PCN #:	2009007A	PCN ISSUE DATE:	November 30, 200	09			
PCN TITLE:							
Change to CS-Mount Lens Holder Exterior Appearance							
REVISION:	1.0 CUSTOMER CONTACT: sales@ptgrey.com		<u>n</u>				
TYPE OF CHANGE:							
✓ Mechanical✓ Firmware S	☐ Electrical Specification ☐ Part Number ☑ Mechanical Specification ☐ Selling Price or Structure ☐ Firmware Specification ☐ End-Of-Life Status (enter new status) ☐ Regulatory or Compliance			status)			
PLANNED FIRST	PLANNED FIRST SHIP DATE / SERIAL NUMBER:						
December 1, 2009 (serial number cutovers for specific part numbers available upon request) NOTE: See below for a detailed list of dates by part number							
AFFECTED PAR	T NUMBER(S):						
Part Number	Description		First Ship Date				
CMLN-13S2C-CS	1.3MP Color Chameleon USB 2.0 Camera 1/3" CCD CS-Mount			Dec 1, 2009			
CMLN-13S2M-CS	1.3MP B&W Chameleon	1.3MP B&W Chameleon USB 2.0 Camera 1/3" CCD CS-Mount Dec 1, 2009

Document Number:	PCN2009007A
Revision Number:	1.0
Revision Date:	27-Nov-09
Document Availability:	Public Distribution

Figure 1: Revised unpainted CS-mount lens holder (left) and previous black anodized version

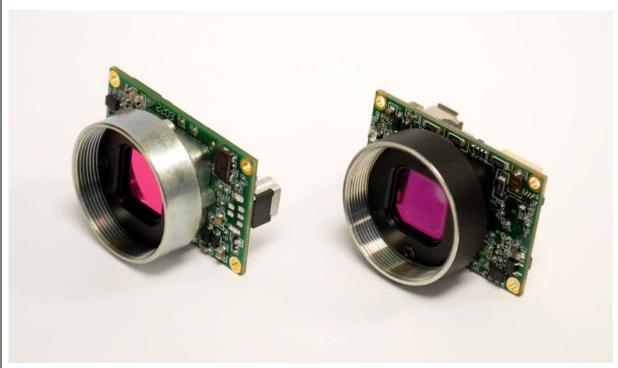
As of the Planned First Ship Date, the exterior of the CS-mount lens holder used by the Affected Part Number(s) will no longer be anodized (painted) black. This mechanical change is considered to be a minor change that extends only to the appearance of the CS-mount lens holder, which will no longer be painted. The change is illustrated in Figure 1 below.

- Minimal change to the exterior appearance of the lens mount
- No impact on fit, function or reliability
- No change to material (zinc)
- · No change to dimensions or weight
- No change to the lens holder threading or barrel length, and therefore no change to back focal length or flange back distance
- No observable change in appearance for products housed in a case (outside of lens mount not visible)
